**From:** KEARNS, Alicia <[REDACTED]>  
**Sent:** Tuesday, March 19, 2024 4:44 PM  
**To:** BEIS Correspondence <[correspondence@energysecurity.gov.uk](mailto:correspondence@energysecurity.gov.uk)>  
**Subject:** Alicia Kearns MP Community Group Letter for Rt Hon Claire Coutinho MP

Mallard Pass Action Group

### **Mallard Pass Solar Plant NSIP application**

**Essendine Historic church** flooded again by the river deluge from Carlby.

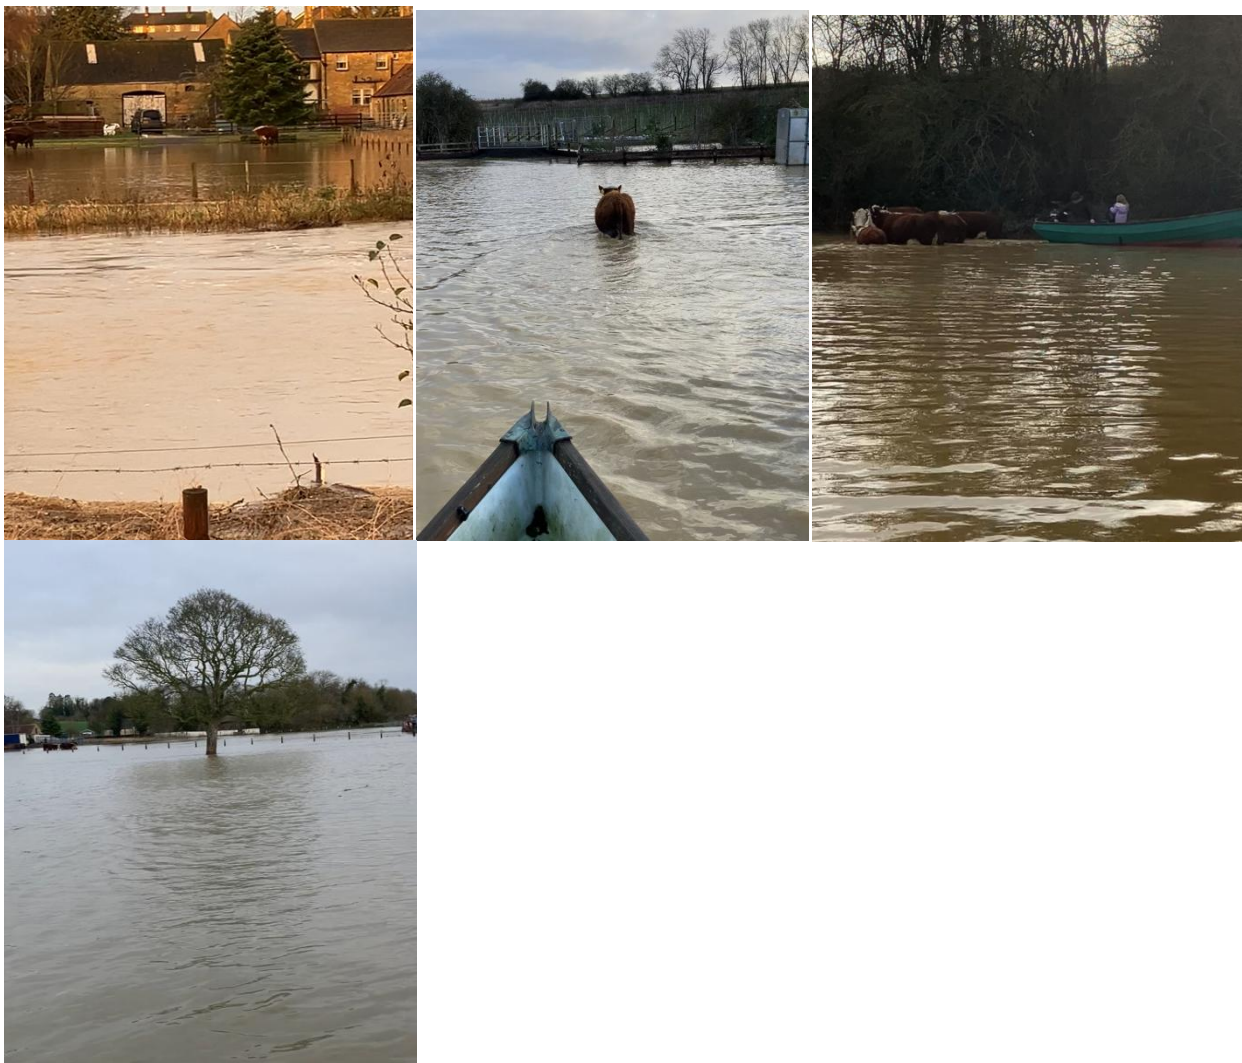
The graveyard was completely submerged; 3 ft of water in the church, worst damage on record; organ needs repairing; the pulpit was washed into the Nave and damaged; all altar linen and service books were damaged; a recent grave was underwater.

**Mallard Point vineyard, marquee business and farm**

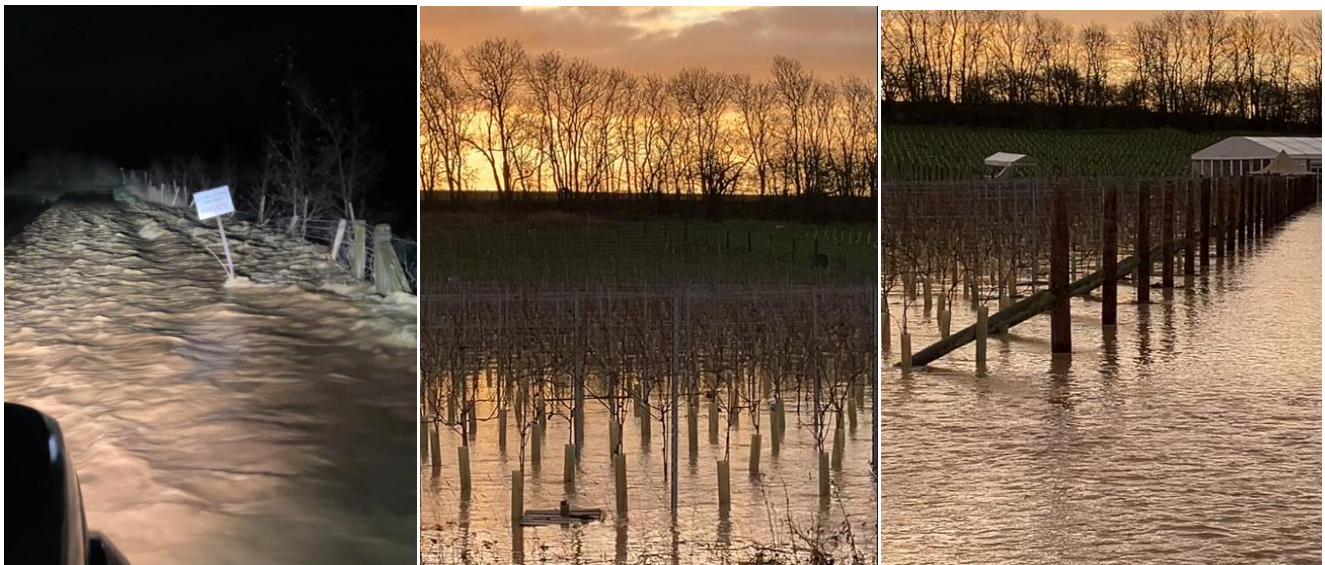
In theory this area had their 1 in 100 chance of flooding this badly in 2019, It is only 2024 and the solar plant application is proposed to last 60 years.

Farmland under water, cattle nearly submerged. Mallard Pass site just above old railway embankment

Marque business afloat

Mallard Point vineyard entrance a running river (white foam)

Anglian water pump station 5ft under water, sewage overflowing onto farm premises.
